NASA/TM-2008-215112

# Silent Aircraft Initiative Concept Risk Assessment

*A risk assessment of the Silent Aircraft Initiative's SAX-40 concept design for extremely low noise has been performed. A NASA team composed of subject-matter experts and systems analysts developed a list of 27 risk items, and evaluated the level of risk for each item in terms of the likelihood that the risk would occur and the consequences of the occurrence. The following risk items were identified as "high risk," meaning that the combination of likelihood and consequence put them into the top one-fourth of the risk matrix: structures and weight prediction; boundary-layer ingestion (BLI) and inlet design; variable-area exhaust and thrust vectoring; displaced-threshold and continuous descent approach (CDA) operational concepts; cost; human factors; and overall noise performance. Risk management strategies of either mitigation, avoidance, assumption, or transfer were recommended for each risk. In addition, several advanced-technology baseline concepts were created to serve as a basis for comparison to the SAX-40 concept. These comparisons indicate that the SAX-40 would have significantly greater research, de

Figure 4. High bending stress associated with a noncylindrical pressure vessel.

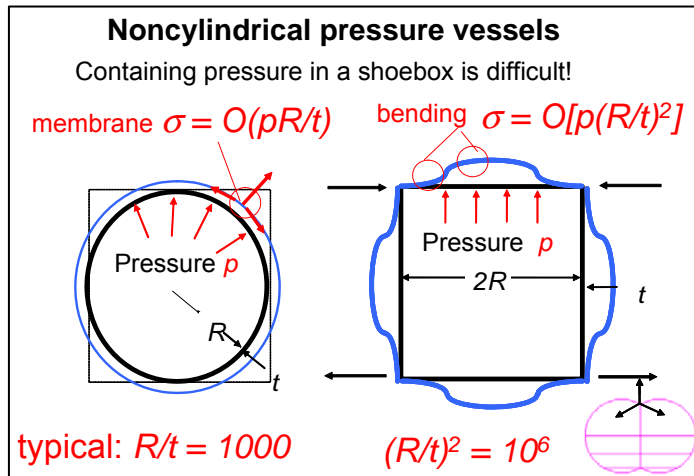
In the BWB (refs. 10 and 11) noncircular pressurized fuselage, the stress levels may be one order of magnitude higher than those for a conventional design (ref. 12). The high stress and weight problem that is associated with the BWB pressurized cabin can be explained by examining Figure 4.

Figure 4 illustrates both a cylindrical and a square-box fuselage under internal pressure  $p$ . In a cylindrical pressure vessel of radius  $R$  and skin thickness  $t$ , the pressure is resisted by uniform stretching; the resulting membrane stress is equal to  $p(R/t)$ . In the BWB box-like fuselage, the nearly flat upper cabin wall resists the pressure by bending deformation. Let us model the flat upper cabin wall as a simply supported beam or plate of length  $l$ , with thickness  $t$ ; then, the maximum bending stress is equal to  $0.75p(l/t)^2$ . If we assume that  $R$  is of the same order as  $l$ , then the bending stress is one order of magnitude higher than the membrane stress. The problem is aggravated by the nonlinear effect of the compressive load as it acts on the deflected beam or plate; hence, significant effort must be made to design an efficient structure with a minimal weight penalty that results from the noncylindrical fuselage.

Figure 5. Sample 335-passenger layout for volumetric sanity check.

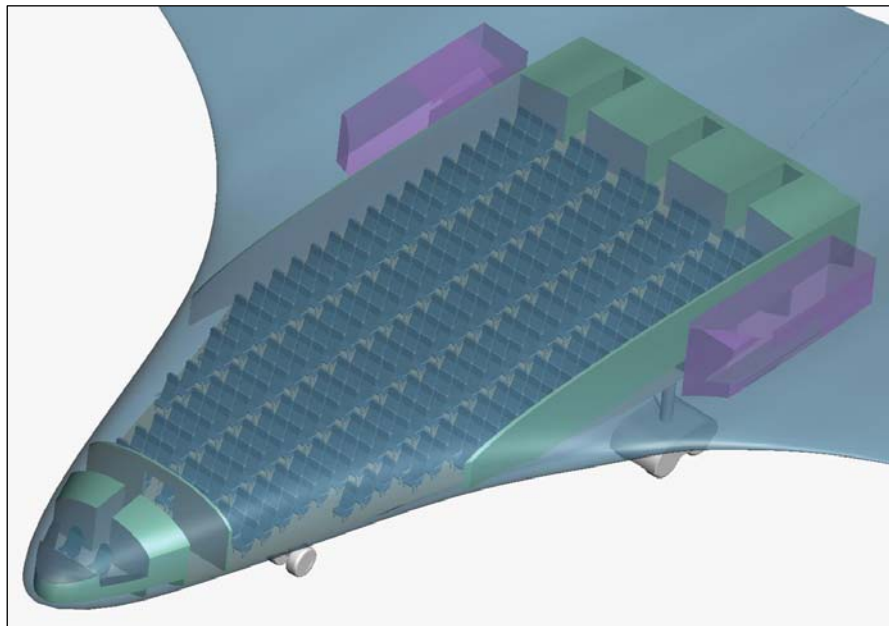
However, to provide a first-order assessment of this risk item, a 3D layout was developed utilizing Pro-Engineer.<sup>TM</sup> Starting with the initial graphics exchange specification (IGES) file provided by SAI, the cabin, cockpit, galleys, restrooms, fuel tanks, cargo bay, retracted landing gear, and major bulkheads and frames in these areas were sized and placed within the OML. A high-density seating arrangement of 335 passengers was used, which corresponds to the current seating density of the 767. Figure 5 shows that the SAX-40 can easily accommodate the design load of 215 passengers.

The large cubes that are situated in the rear of the passenger cabin represent the volume that is required for the galleys and restrooms. The rectangular volumes that are located outboard from the seating area show the required fuel tank size. A large volume clearly exists in the wings for additional fuel, as pointed out in reference 5. However, any additional fuel would increase both the weight empty and the gross weight of the vehicle, which would have a negative impact on the noise performance. Figure 6 shows the geometry of the landing gear retraction. Again, adequate volume is available.

Figure 6. Landing gear retraction geometry.

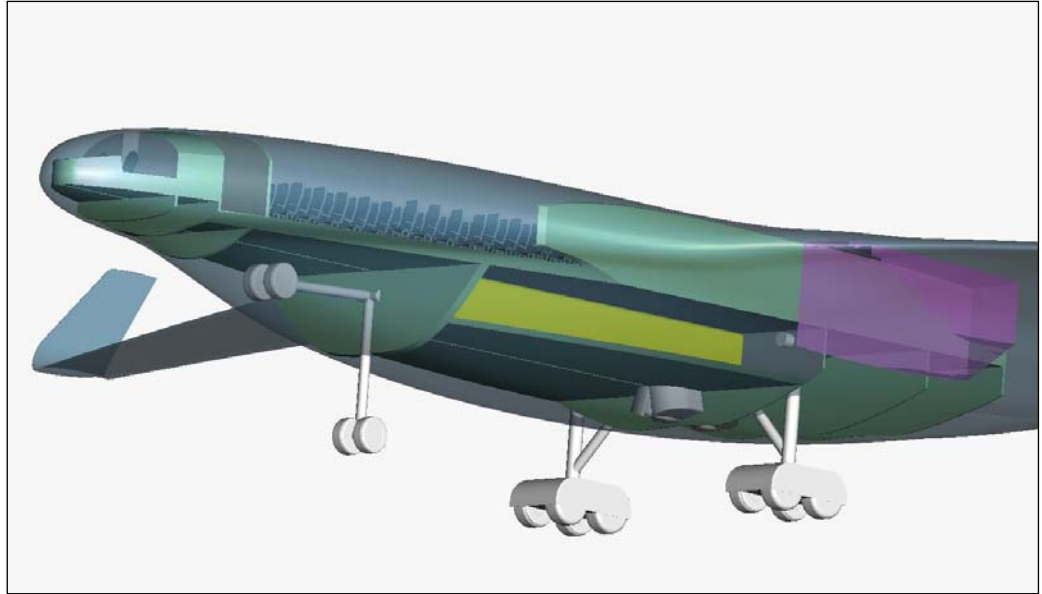
Based on the 3D modeling, issues with the internal packaging of this design are not likely. The BWB configuration in general, and the SAX-40 concept in particular, have relatively large amounts of internal volume. Should a packaging issue arise, however, the consequences would not be minor. Major redesign of the components or OML changes would be required. These changes could easily compromise the attainment of the mission requirements by 10 percent or more.
